# Chevrolet Dealer Service Information Bulletin

75-I-3  
 Number: \_\_\_\_\_  
 I  
 Section: \_\_\_\_\_  
 Nov. 4, 1974  
 Date: \_\_\_\_\_

**Subject:** SEAT BELT STARTER INTERLOCK AND  
 BUZZER DISCONNECT - ALL 1974-75  
 STYLES

**Subject:** SEAT BELT STARTER INTERLOCK AND BUZZER DISCONNECT - ALL 1974-75 STYLES

**Figure 1**

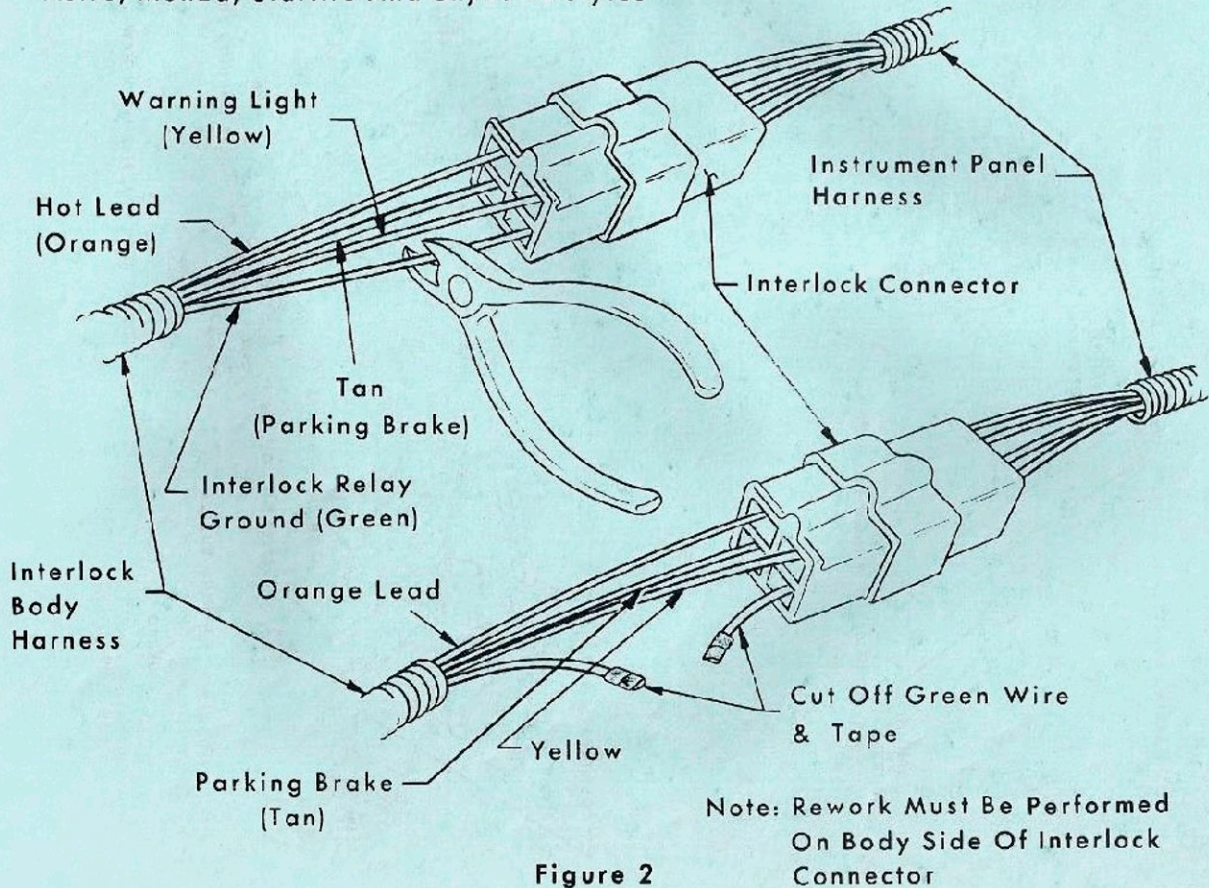
1. Disconnect negative battery cable.
  - . NOTE: If car is not equipped with the starter interlock, proceed to step 4 to disconnect the buzzer only.
2. Locate the interlock harness connector (all except Opel - for Opel, see Step 5).
  - a) On all 1974 and 1975 styles except 1974 Vega, connector with orange, yellow and green leads is located under the left side of the instrument panel on or near the fuse block.
  - b) On all 1974 Vega styles the connector is located under the parking brake cable cover.
3. Cut and tape the green wire on the body harness side of the interlock connector. (See Figures 1 and 2).
4. Disconnect seat belt warning buzzer as follows:
  - A. Chevrolet

**Rework Of Interlock Harness Wires  
For All Styles Except Vega, Astre,  
Monza, Starfire and Skyhawk Series**
